PMA Electricals, PMD, Mixing Segment, and MDI Skeleton Proposal for 10BASE-T1S in D1.2

IEEE P802.3cg 10 Mbps Single Pair Ethernet
Task Force

George Zimmerman
CME Consulting, Inc.
Rosemont, IL, USA March 6, 2018

Figure 146-17—Test fixture

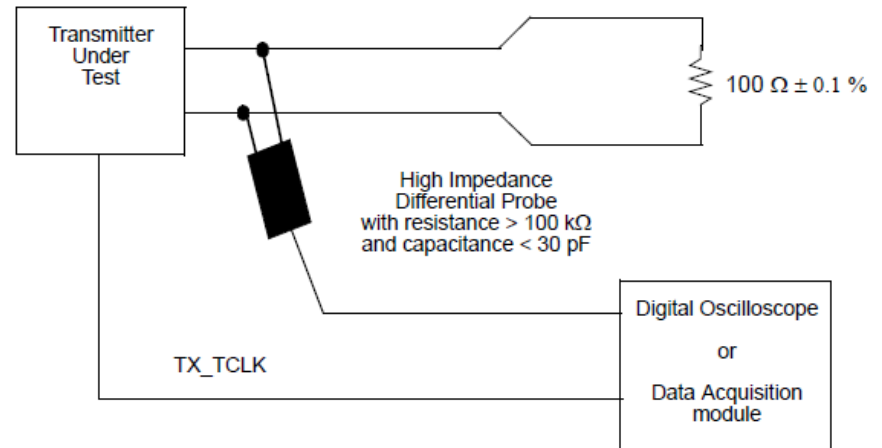
Editor's Note (to be removed prior to draft 2.0):

Copy or reference clauses 146.5.3 and 146.5.4 here as they apply as well for 10BASE-T1S.

- Question: Do we need to add tests including stressing transmitter under line impedance variation?

- Insert text from 146.5.3 and figure 146-17 as **147.4.2 Test fixtures**
- Insert text from 146.5.4 (but not subclauses) as **147.4.3 Transmitter Electrical Specifications**, make 147.4.1.1 to 147.4.1.4 subclauses 147.4.3.1 through 147.4.3.4
- Specify high impedance mode and test mode:
 - Add new test mode 4 to 147.4.1 – High impedance mode
“When the multidrop option is supported and test mode 4 is enabled, the transmitter presents a high impedance to the line as specified in 147.3.3 for the ‘I’ symbol in multidrop mode.”
 - Add test mode 4 and “High impedance mode” to test mode control register
 - Add **147.4.3.5 Transmitter high impedance mode**
In test mode 4, a transmitter supporting the multidrop mode presents a minimum 10 kOhm impedance to the line from DC to 25 MHz.

Figure for Mixing Segment (from 147-11)

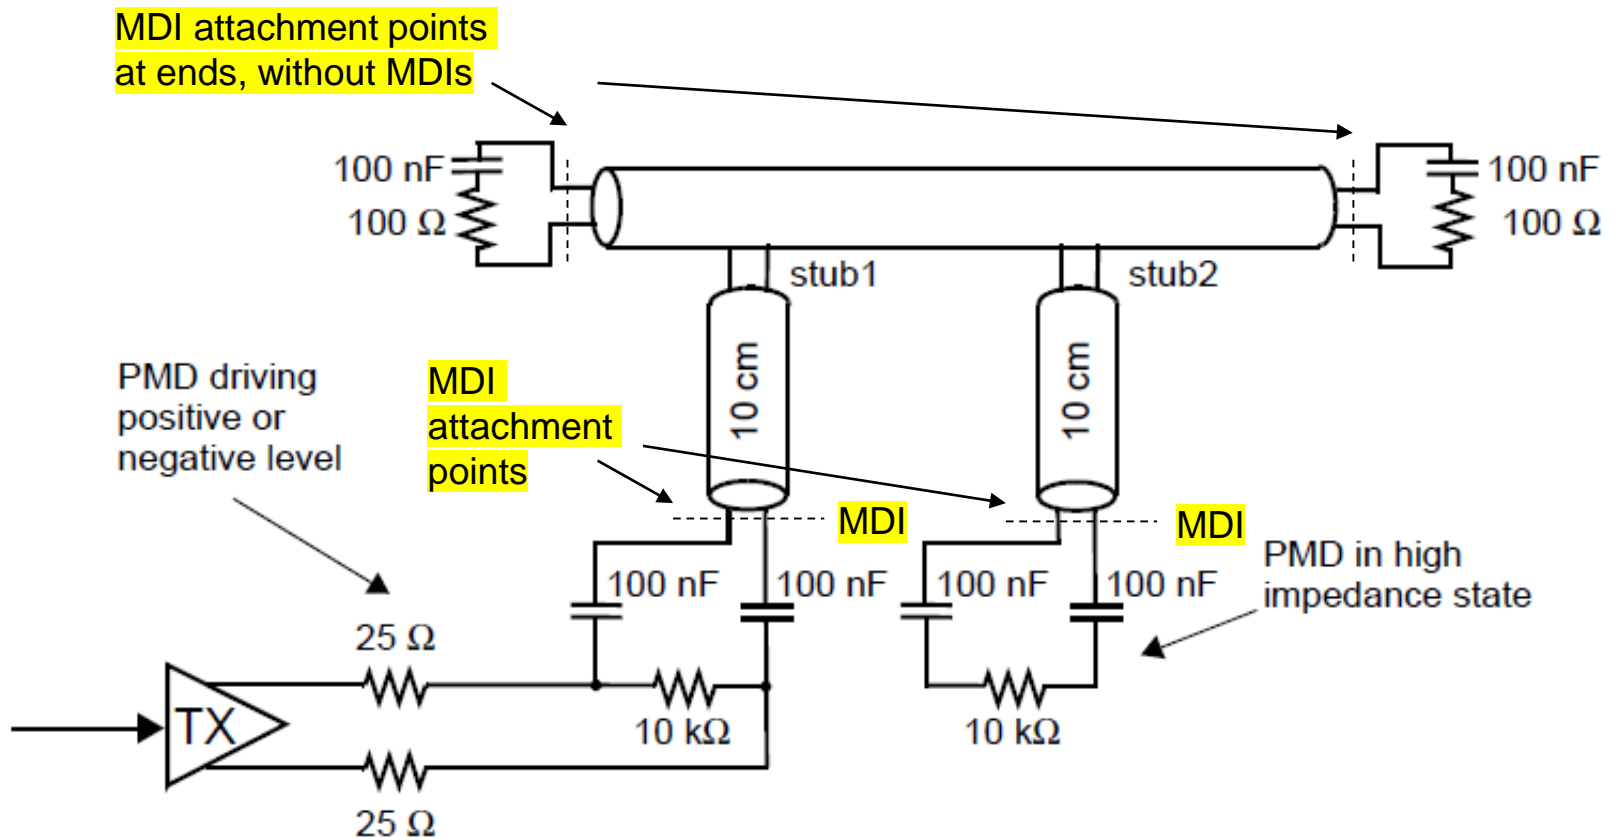
- **Delete 147.5 and subclauses**
 - **Move figure to new ‘mixing segment characteristics’ subclause**
- Add to (new) 147.4.3:
- **Editor’s Note: Reviewers to consider whether additional requirements and test fixtures are needed to test the transmitter tolerance to expected line impedance variations**

- Insert after existing 147.6 (Link Segment specification):
147.7 Mixing segment specification
10BASE-T1S PHYs supporting multidrop mode is designed to operate over media that meets the requirements specified in this subclause. The term “mixing segment” used in this clause refers to single balanced twisted-pair cabling which may have more than two MDIs attached.
A mixing segment is specified based on automotive cabling supporting up to at least eight nodes and 25 m of cabling. An example mixing segment and reference points is shown in Figure 147-xx.
- Insert at this point, Figure 147-11 from slide 10 of Beruto_3cg_03_0318.pdf as Figure 147-xx and number appropriately, with additional labels as shown on next slide.
